NRL/MR/7441--94-7516

Digital Mapping, Charting, and Geodesy Analysis Program Technical Review of Vector Smart Map Prototypes 1 and 2

January 19, 1995

Figure 18. V_{Map} and ITD disagreement on placement and number of fords

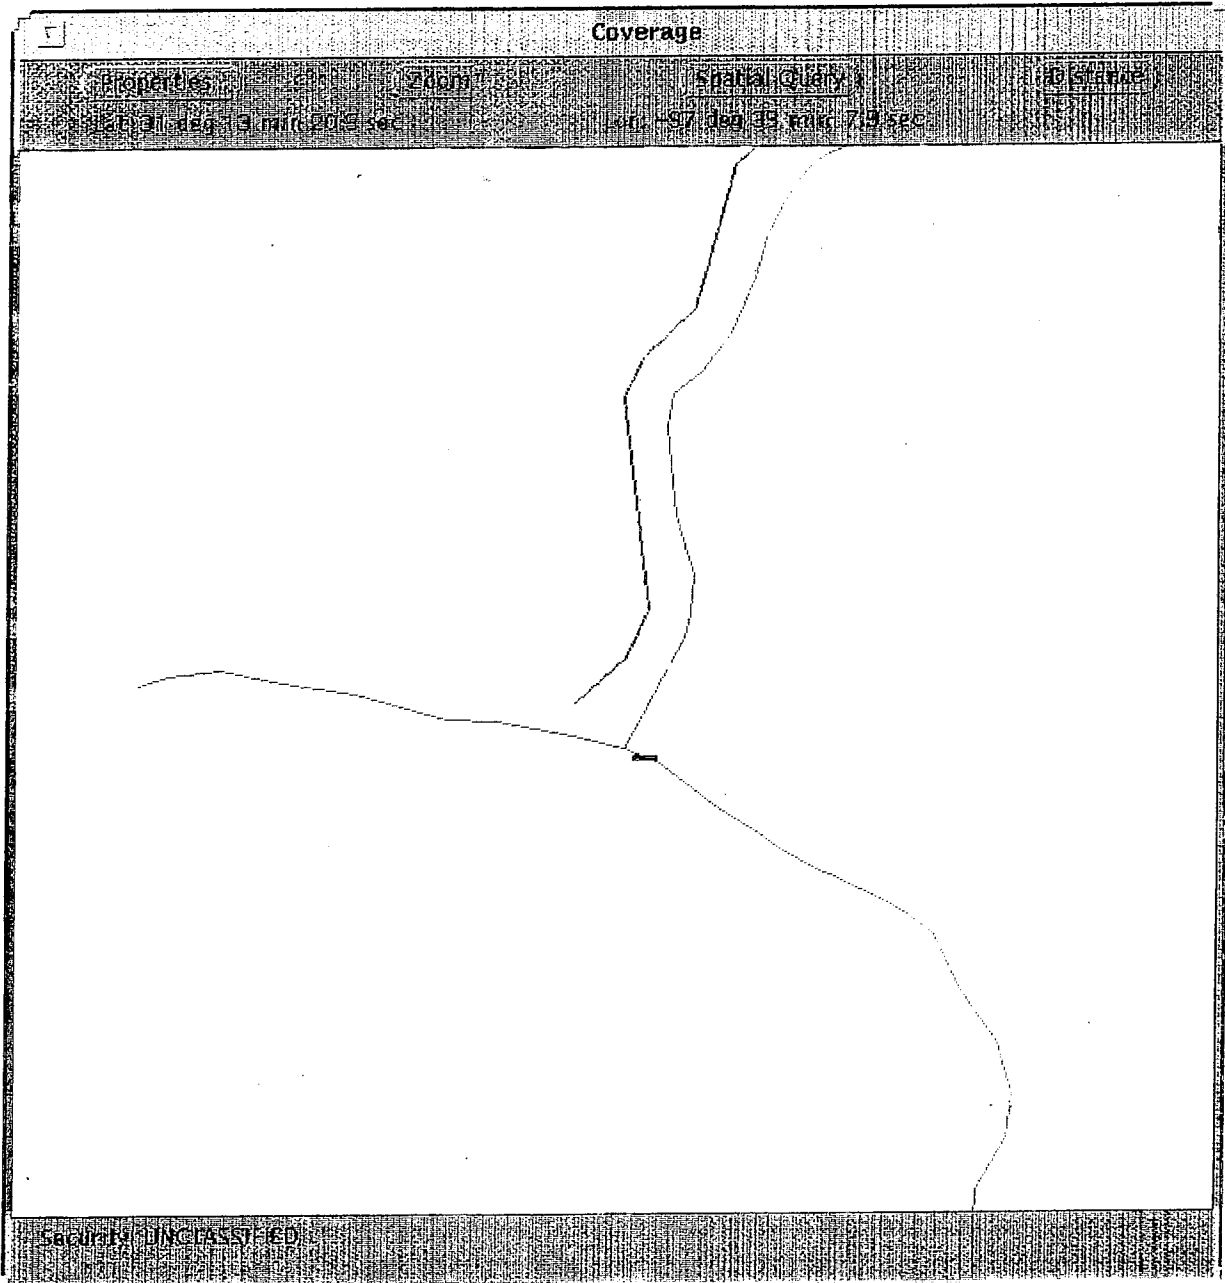
Figure 18 further shows the disagreement between the placement and number of fords.
